Modify Table 9.1:

New Section 9.2.1.5:

9.2.1.5 HDCP IIA Authentication Protocol format

Figure x shows an HDCP IIA Authentication Protocol AECPDU.

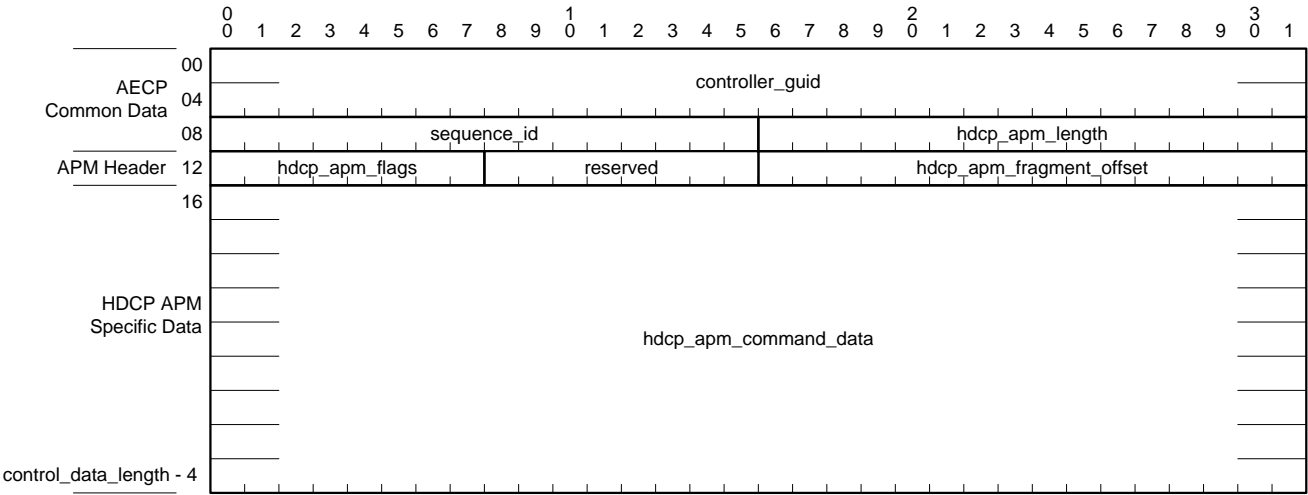
HDCP IIA Authentication Protocol adds the following fields to the AECPDU following the **sequence_id** field:

- **hdcp_apm_length**: 16 bits
- **hdcp_apm_flags**: 8 bits
- **reserved**: 8 bits
- **hdcp_apm_fragment_offset**: 16 bits
- **hdcp_apm_command_data**: (hdcp_apm_length – 4) octets
